## Response to Submissions

UNSW D14 Academic Building, Kensington  
Campus  
State Significant Development (SSD 9606)

Submitted to Department of Planning and  
Environment

On behalf of The University of New South  
Wales, Sydney

**Figure 1** Amended Landscape Proposal

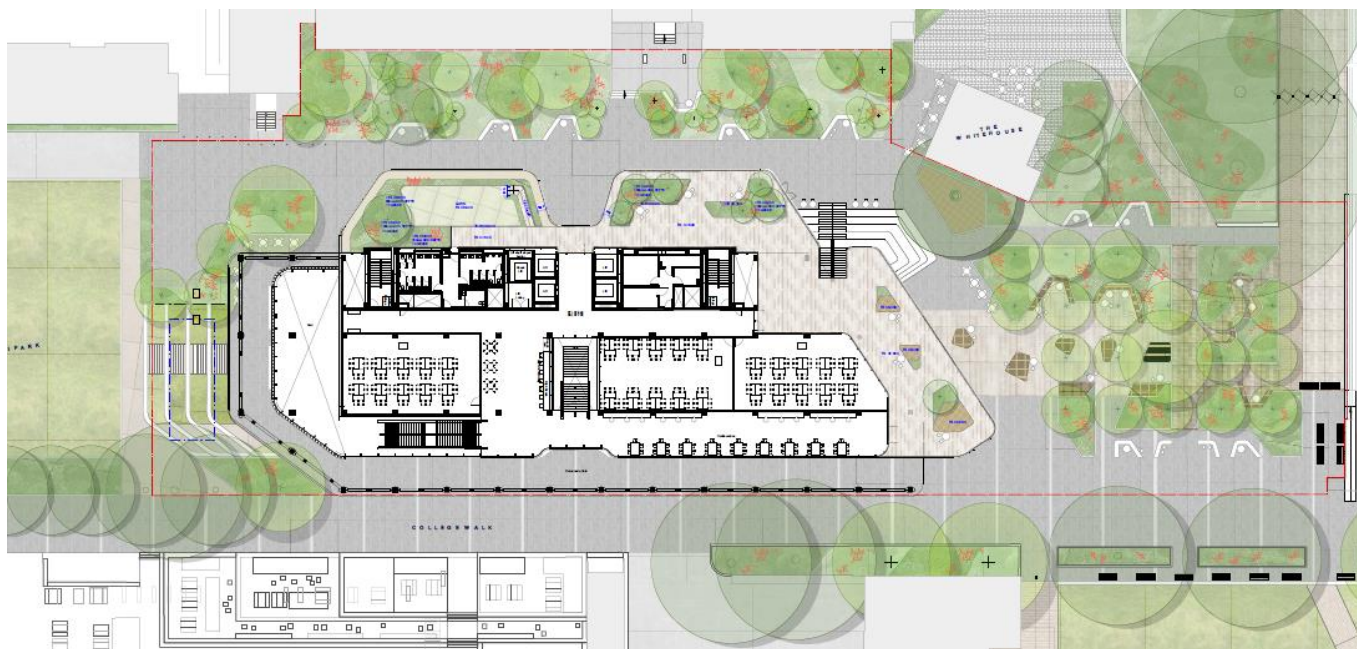
- The SSD needs to detail how the development will address the District Plan's sustainability planning priorities and strategies particularly in relation to increasing tree canopy cover and delivering Green Grid connections.

- The OEH recommends that the development incorporate green walls, green roof and or a cool roof in the design of the building. Specific green cover opportunities are identified to increase overall area of landscaping at the Level 1 terrace, the Alumni Terrace and the Fig Tree Courtyard Space and White Bleachers.
- Additionally, increasing the green space would be consistent with Item 5 of the SEARS requirements.

- A planting plan and plant schedule that includes proposed species, botanic and common names, pot size at time of planting, quantity, location, dimensions at maturity and any other details required to fully describe the works;
- A schedule showing the number (as a percentage of total) the endemic, native and exotic species that will be used in all new planting;
- A schedule showing the number of new canopy trees to be planted compared to the number of trees to be removed (both as part of this proposal and under Section 5 of the Environmental Planning & Assessment Act); and
- Provision of a Lighting Strategy for paths and gardens to assist with wayfinding and surveillance/security.

As illustrated at **Figure 1** the amended proposal provides an overall improved outcome from a landscape and public domain amenity perspective. In response to the OEH comments, the overall landscaped area has been increased at ground level, and high quality landscaped edges are proposed to the site's interfaces to the north, east and west.

The extent of landscape area on the Level 1 terrace has also been increased and consists of an open lawn area, some mounded landscaping and tree plantings to the north west edge and additional plantings in large planters with integrated seating opportunities. Soil depth within some of the planters will be deep enough to accommodate small evergreen trees and have been oriented with an objective to provide an enhanced transition and separation to the university's residential accommodation to the north of the site.

**Figure 3** Understorey relationship between the proposal's podium and the HCA

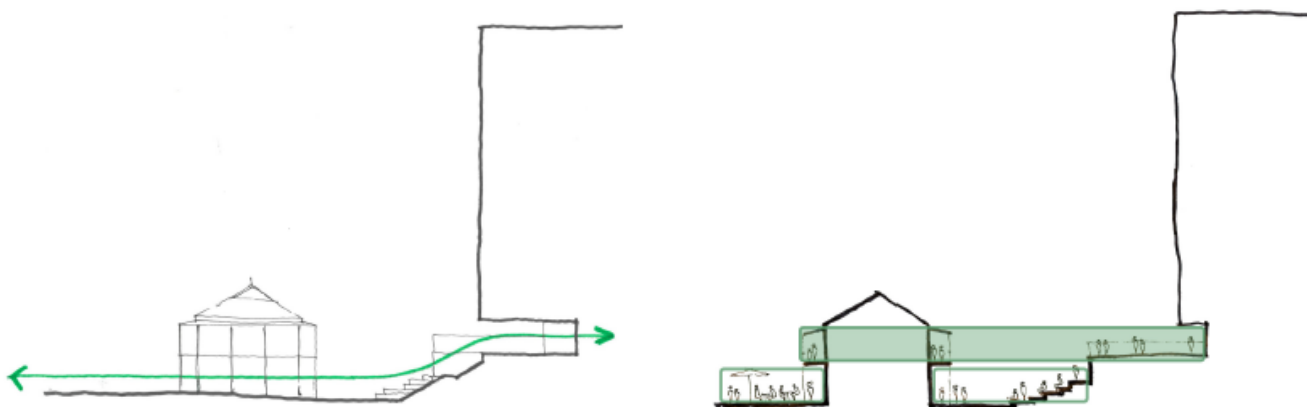
- Council requests that the scale of the development is reduced on the eastern and south – eastern portion of the proposed development. It is considered that the bulk and scale of this section is unnecessary and excessive.
- Council is of the view that the deletion of the lower two storey ground plane element and a revised design of this section of the development will result in an improved built form and interface with the heritage conservation area and Whitehouse heritage item.

Within the eastern section of the site, the lower storey edges have been carefully designed to provide an improved relationship between the new Building D14, the Whitehouse and the HCA. This relationship is illustrated at **Figures 3 and 4** below. The new building is also further setback, when compared to the existing UNSW Hall Building, providing a more generous curtilage to the HCA and in particular the Whitehouse (refer to **Figure 5** over the page).

The terrace of the two storey edges are designed to present as an extension of the ground plane, comprising an outdoor terrace space. The north-eastern edge has also been designed to include masonry bleachers. The bleachers along with the Whitehouse and the high-quality landscaping to the north will further activate the north and north-eastern interface of the site and importantly provide a new public space for student gatherings or private contemplation and relaxation. In this regard, the two storey element is considered to be a good design outcome for the site.

**Figure 9** Amended Project Footprint in relation to the HCA

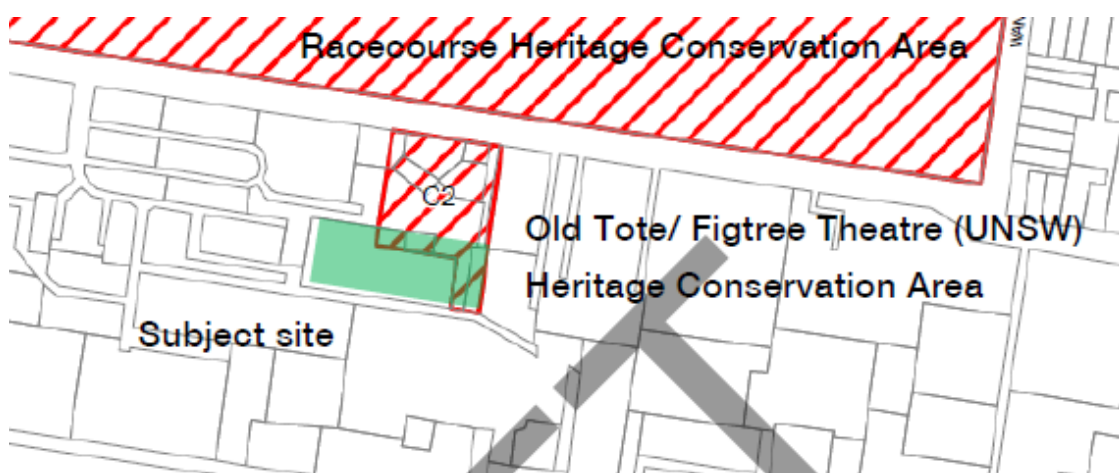
- The proposed development encroaching into the Heritage Conservation Area.
- A deep, long and tall building being constructed next to the Heritage Conservation Area and items of key heritage significance. Council's view is that the façade features and architectural quality of the building should not be used to justify the height, bulk, and scale of the proposal.
- The south eastern splayed corner is considered to encroach into the curtilage of the Whitehouse. This design feature is also seen to have detrimental impact on the existing connective space and view corridor between High Street and the Quadrangle Lawn.

An amended Statement of Heritage Impact (SOHI) has been prepared by TKD Architects (**Appendix D**) to consider and assess any potential heritage impacts due to the extended landscape footprint / site area, which marginally encroaches into the HCA (refer to **Figure 7**). This portion of the HCA largely consists of bitumen or hardstand paving and does not include any items of heritage significance.

The extended site works proposes to largely replace 'make good' bitumen paving originally proposed with landscaped areas consisting of additional trees, understorey plantings and seating area. This is seen to provide an improved outcome from a heritage perspective, in that the new landscaped areas will complement the HCA in addition to providing an improved softer transition between the new development and the heritage significant items of the HCA (the Whitehouse, the Old Tote, Fig Tree Theatre and the Fig Trees). The amended proposal will also continue to provide an improved setback and curtilage response to the HCA relative to the existing University Hall student accommodation building. The materiality and articulation proposed for the new D14 Academic Building are also sympathetic and complementary to the HCA.

On this basis, it is considered that the additional works and encroachment of the HCA will not result in any adverse heritage impacts. Further, TKD Architects confirm in its amended Statement of Heritage Impact that the proposed revised package of landscaping works are seen to provide an overall positive heritage outcome.

**Figure 10 Proposed SSDA Tree Strategy**

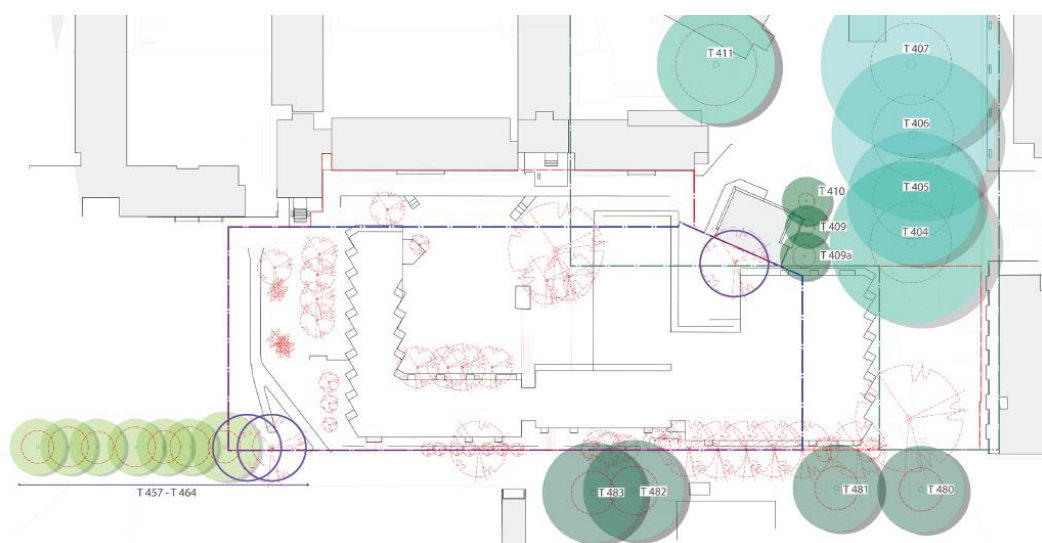
The RCC submission acknowledges that a total of 34 trees are proposed to be removed under Part 5 of the EP&A Act. RCC accordingly requests a Tree Management Strategy to ensure that there will be no net loss of tree canopy within the campus. In addition, clarification is sought with regard to the Arborist Report and tree management:

- Part 4.3, Discussion, of the Arborists Report, details that trees NR1, NR4-NR9, T465-479 & T1119-1228 are proposed for removal, but none of these have been shown on the plans, and have also not been assessed in the Arborist Report. As such, this remains an issue, with comment unable to be provided until the required information is provided.

- T404-408 & T411 (Moreton Bay Figs, included in Council's Significant Register as discussed above) and T480-483 (Hill Weeping Figs, also identified in Council's Register as 'component/associative plantings') have all been assigned a High Retention Priority, with new services to encroach some of their TPZ's by up to 10%, at 12m offsets, which should be manageable given the resilience of the species, with relevant Tree Protection conditions imposed.

- T402 is a large standalone Flooded Gum also of high value, with the proposed services as currently shown deemed unacceptable given that a major encroachment of up to 35% of its TPZ would result, which the tree could not sustain, so Protection conditions formalise the Arborists recommendation that the plans be amended so as to provide greater offsets to both its west and south.

In relation to impacts to trees within the project site, the amended SSDA package clarifies the number of trees proposed to be removed as three (3). This includes Tree 1119 (to the south of the Whitehouse) and Trees 463 and 464, to the south-east of the proposed building adjacent to College Walk. For further assessment of the trees to be removed and the proposed tree protection measures for retained trees, refer to the revised Arboricultural Impact Assessment (provided at **Appendix L**). Refer to **Figure 10** below for a visual representation of trees to be removed and retained.

In addition, as part of the landscaping scheme a total of 38 new tree plantings along with understorey plantings are proposed. Refer to pages 17 and 23 of the Amended Landscaping Report at **Appendix B**. As such, the overall tree removal impact is considered to be minor.
